**COUNTY OF SAN LUIS OBISPO  
DEPARTMENT OF PLANNING AND BUILDING  
STAFF REPORT**

MEETING DATE August 25, 2005	CONTACT/PHONE Brian Pedrotti 788-2788	APPLICANT Mark Godfrey	FILE NO. TRACT 2574 S030062T
<b>SUBJECT</b> Request by Mark Godfrey for a Vesting Tentative Tract Map to subdivide an existing 19.2 acre parcel into seven parcels of between 3.15 and 2.50 acres each, for the sale and/or development of each proposed parcel. The proposed project is within the Residential Suburban land use category and is located at the northeast corner of Badger Canyon Lane and Fox Canyon Lane, west of Corbett Canyon Road, approximately 1 mile north of the City of Arroyo Grande. The site is in the San Luis Bay (Inland) planning area.			
<b>RECOMMENDED ACTION</b> 1. Adopt the Negative Declaration in accordance with the applicable provisions of the California Environmental Quality Act, Public Resources Code Section 21000 et seq. 2. Approve Vesting Tentative Tract Map 2574 based on the findings listed in Exhibit A and the conditions listed in Exhibit B

Godfrey Tract Map TR-2574

**6A**

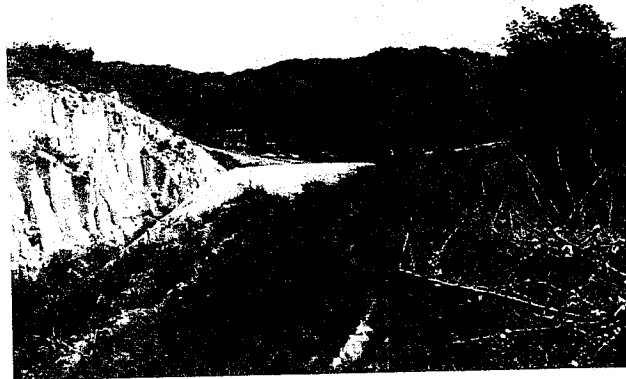
View of Northern boundary  
of Lot 6. Building site on  
map appears to include cliff  
line above drainage area to  
past oak tree in center of  
photo.

593 6F

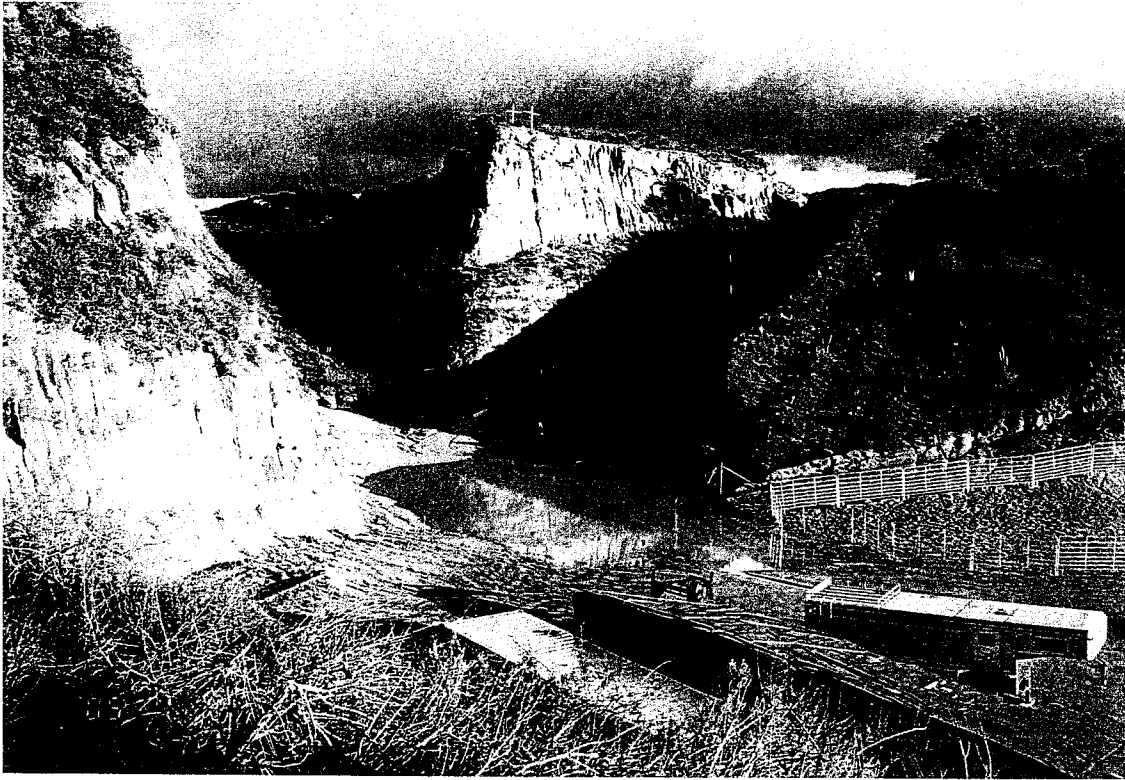
View of cliff area on boundary of Lot 6. Developer Godfrey, Had stated the best thing would be to bulldoze this cliff since he needed all the land he could get to make the minimum lot size.

6G

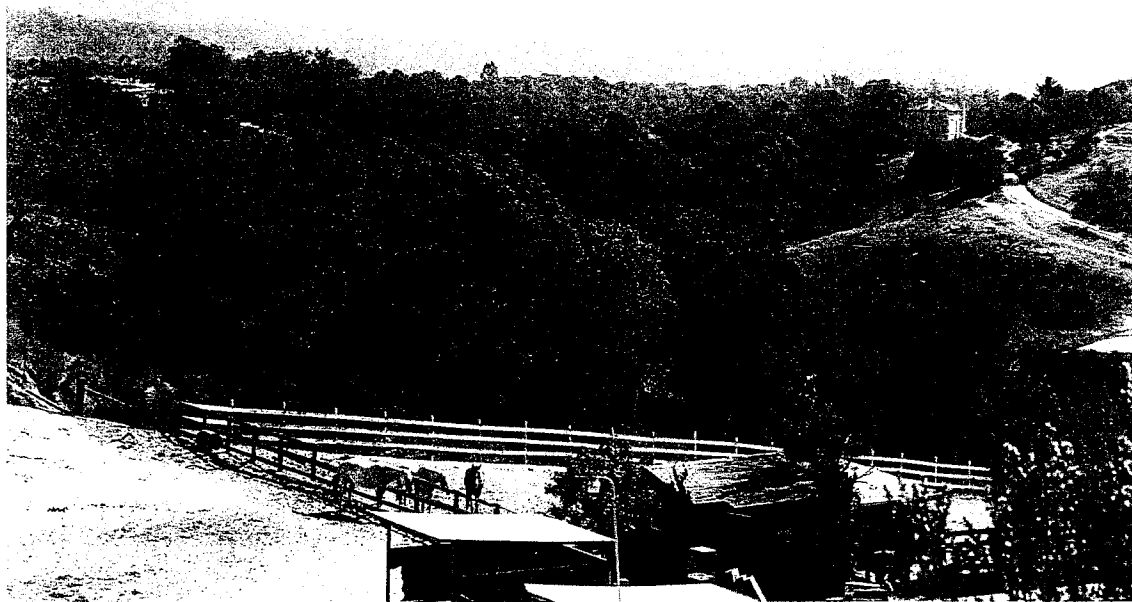
- 2) Add to list of protected trees all oak trees on Northern boundaries of proposed lots 4 & 6 (see photo 6G). This is for soil stabilization and visual effect of property and component of wildlife habitat

View of Northern boundaries of Lots 4 & 6. Request all oak trees on these boundaries be protected. The trees provide stability to soil on steep slopes and visual separation between properties. These trees do not currently appear to be addressed on current tree protection plan.

5B

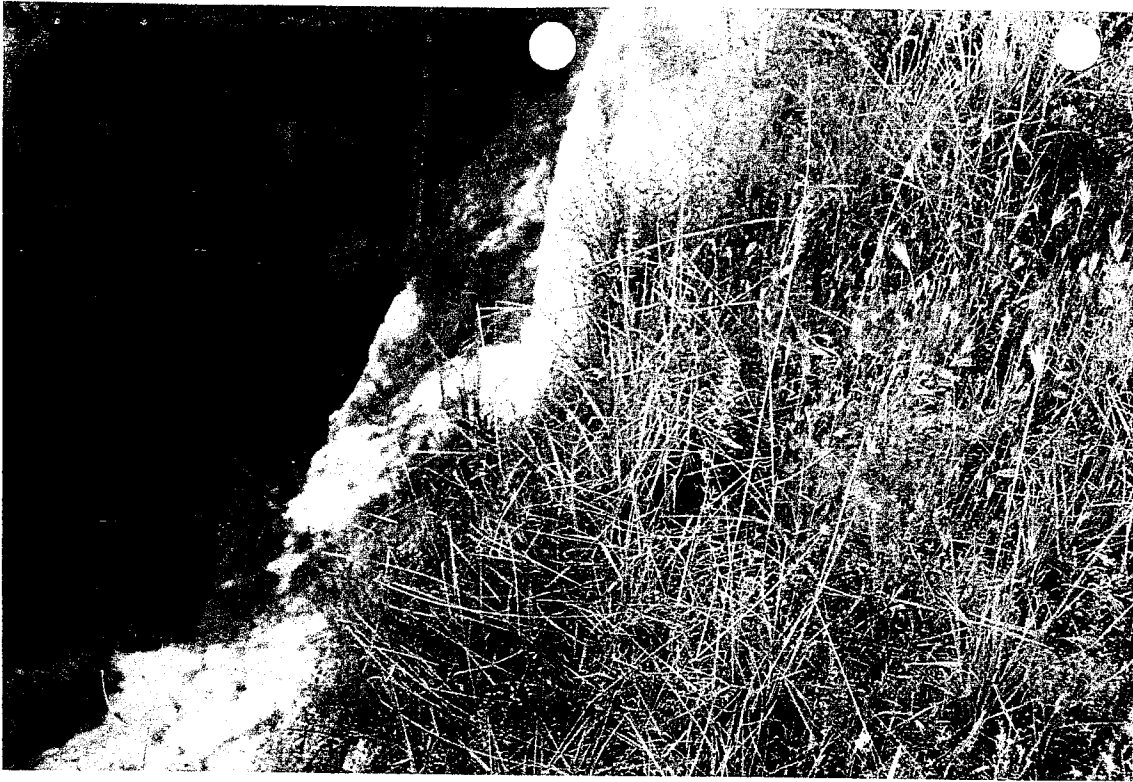
Property line is approximately 5 foot from rim of 300-400 foot cliff. Plans show retention basin very near to cliff line.

Are further setbacks required for protection of habitat and erosion control?
